## SYDNEY WESTERN CITY PLANNING PANEL

Panel Reference	2017SSW002
DA Number	1472/2016
Local Government Area	Camden
Proposed Development	Construction of four (4) x seven (7) storey residential flat buildings, containing 185 residential units and two (2) basement levels containing 245 carparking spaces, landscaping and associated works on proposed Lot 3 in a resubdivision of 28 Ingleburn Road.
Street Address	28 Ingleburn Road, Leppington
Applicant/Owner	Balintore Ingleburn Pty Ltd C/O Design Cubicle Pty Ltd  Balintore Ingleburn Pty Ltd
Number of Submissions	Six (6) objections were received.
Recommendation	Refusal
Regional Development Criteria (Schedule 4A of the EP&A Act)	Capital investment value >\$20 million CIV - \$42,301,696
List of All Relevant s79C(1)(a) Matters	<ul style="list-style-type: none"> <li>• State Environmental Planning Policy (State and Regional Development) 2011</li> <li>• State Environmental Planning Policy (Sydney Region Growth Centres) 2006</li> <li>• State Environmental Planning Policy No 55 – Remediation of Land</li> <li>• State Environmental Planning Policy No 65 – Design Quality of Residential Apartment Development</li> <li>• State Environmental Planning Pol

**Image 3 – Proposed site plan**

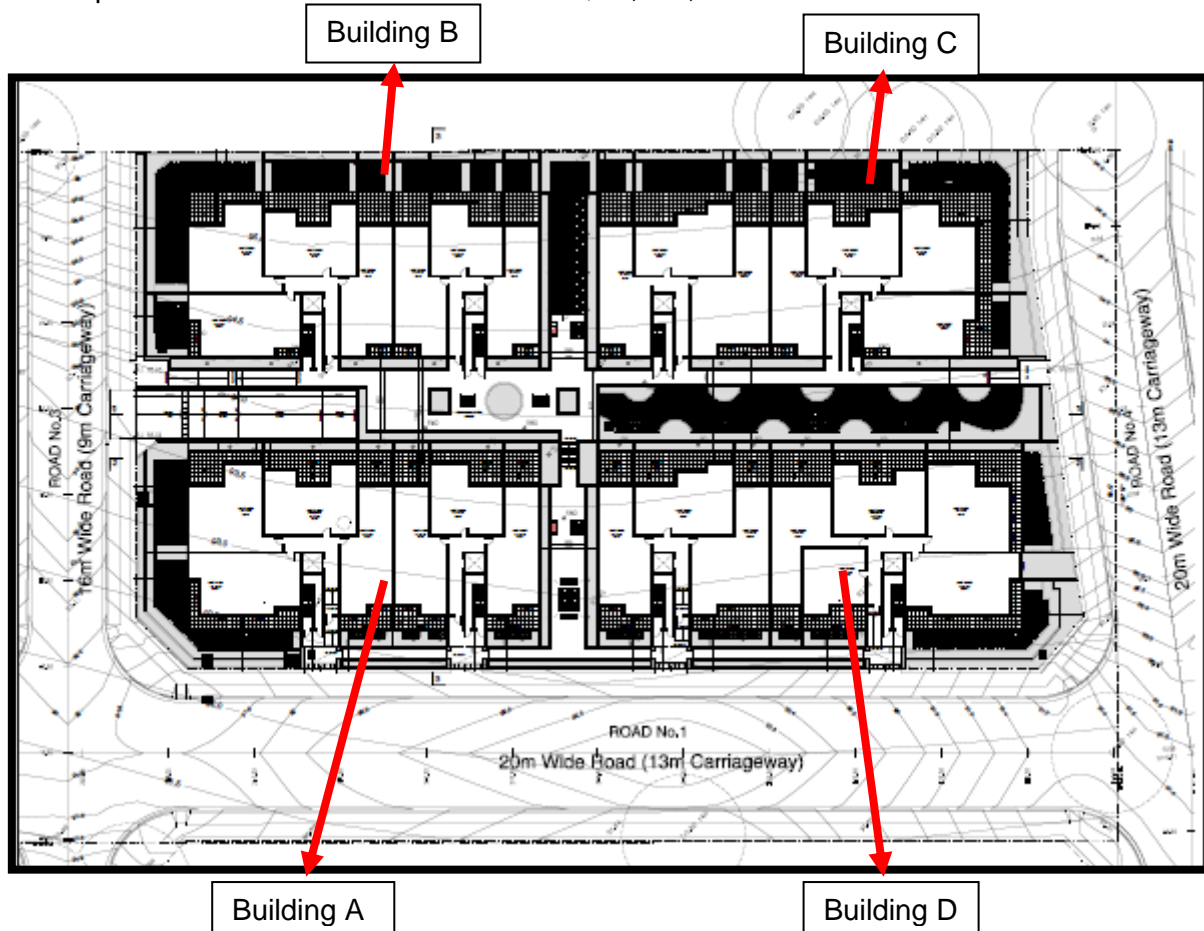
It is considered that the development does not have adequate regard to the design quality principles and lacks an understanding of the future desired character of the precinct. The development is considered to have an inappropriate built form and scale and does not provide a 'human scale' to the development. The development fails to activate the frontage of adjoining streets, with residential lift lobbies also not addressing the street directly.

There are amenity impacts to adjoining residences and to proposed buildings on site through insufficient building separations and overshadowing, including overshadowing of future streets. In addition, the development fails to provide an adequate area of communal open space, which is extensively overshadowed throughout the day and which is also segregated from Building A and D through poor pedestrian access.

The proposed buildings to the west of the lot (Buildings B and C) are oriented in a way that will not contribute to the streetscape and activate the street frontage. The proposed residential entry for the western buildings (Buildings B and C), are set deeply into the lot and will not contribute to the character of streetscapes and street activation. Residential entries should address the streets. The orientation of the western buildings will also cast a large amount of shadow to the proposed communal open space in the middle of the lot, based on the shadow diagrams in the architectural package. This will result in less than 50% of the proposed communal open spaces receiving

adequate 2hrs solar penetration. Hence, the rearrangement of the orientation of these buildings would be necessary in any further proposal submitted.

Self-overshadowing is significant from the western buildings to the eastern buildings, including over the common open space area located between the buildings. The proposed lower levels of the buildings along the 20m Residential Collector are likely to be overshadowed by the buildings to the west. In addition, the reduced floor to floor height (2.9m) on each level coupled with significant self-overshadowing will sacrifice solar access to the proposed units.

The exposed basement ramp is considered to compromise the visual quality of the public domain and the ramp should be encapsulated into a built form. Considering the overshadowing issue to the communal open space on the ground level, significantly improvements are required to enable solar amenity to be received to the ground floor communal open space to provide for better amenity and equitable access to all residents.

The shadow diagrams provided suggest that the communal open space is significantly overshadowed by the buildings to the west. It has not been demonstrated that the minimum 2hrs direct sunlight between 9am and 3pm during midwinter for 50% of the open space is achieved, which is unsatisfactory.

Image 6 – South west elevation ( Road No. 3 )

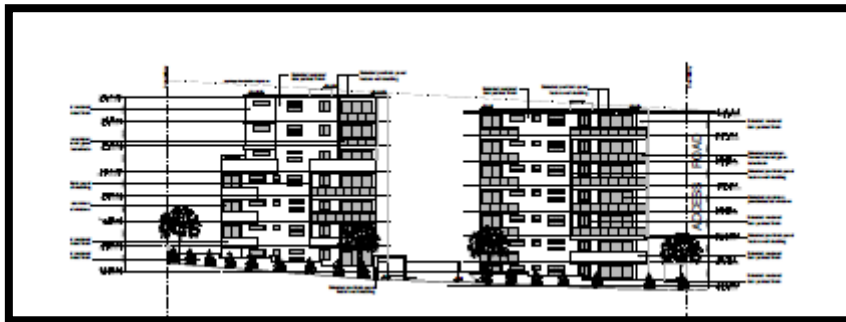
The proposed continuous seven (7) storey street wall proposed along the 20m residential collector road is not an acceptable built form for the subject site and the desired future streetscape as it does not provide a 'human scale' to the development. A two (2) – four (4) storey wall height across the site, with a secondary setback above the podium without any protrusions would allow a pedestrian-friendly streetscape and reduce overshadowing to adjoining streets and lots.

The mismatch between the DCP building height control (in storeys) and the SEPP (SRGC) 2006 which introduces a maximum 21m height control to the subject site can be resolved with the provision of a distinct podium form along the proposed streets. Based on the shadow diagrams provided by the applicant, a large portion of the 20m Residential Collector Road is almost overshadowed throughout the day by the proposed development. It is not acceptable to have a continuous seven (7) storey street wall without any effective break.

The proposed buildings lack articulation on all of the facades. In addition, the proposed development does not adopt quality materials to vary the finishes to create architectural interest, which is heavily reliant on the use of painted render. The development fails to provide a secondary setback into the design to provide breaks between the street wall height and the upper levels. Vertical elements and proper insets are also required to create breaks on the proposed facades every 20m to create visual interest to the facades of the development.
